Site: Mirehaven Pulte Traditional

On June 9<sup>th</sup>, the City issued a Violation Letter (Order) to:

Trash at 9219 Timber Ridge NW

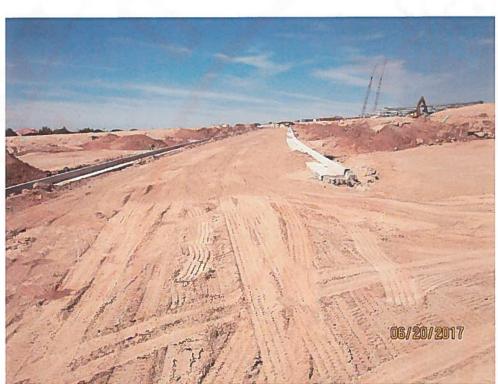
- New Mexico 87103 9251 Time ridge NW
  - 9231 Timber Ridge NW
  - 1836 Cooke Canyon NW
- www.cabq.gov
- 1828 Cooke Canyon NW
- 1824 Cooke Canyon NW
- 9208 Beaver Creek NW
- 9224 Beaver Creek NW
- 1815 Tent Rocks (trash receptacle lot) Paint pollution
- 2. An acceptable wash-out was not provided close enough to the work areas so that subcontractors will use it.
- 3. An acceptable wash-out facility close enough to the work areas so that subcontractors will use it was not provided. An acceptable wash-out (e.g. Outpak) facility was not provided by the front yard spigots.
- 4. Trash was observed on lots in the subdivision.

5. Remove trash and provide trash receptacles close enough to the work areas so that subcontractors will use it.

Long steep section of Vista Ciudad Dr.

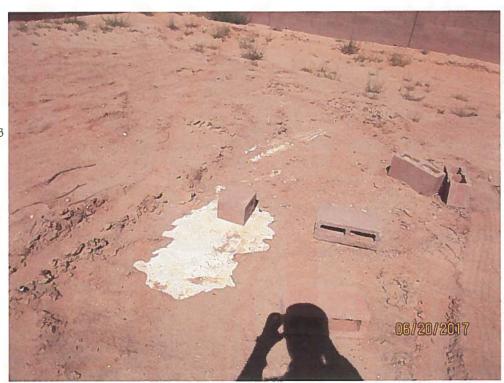
5. Per the approved Erosion and Sediment Control plan wattles were to be placed transverse to the flow direction in Vista Ciudad Dr to help prevent erosion and sediment deposition.

4. Provide an effective erosion/sediment BMP for the long steep section of Vista Ciudad Dr. If the wattles will not be effective due to construction traffic, a sediment pond could be built.
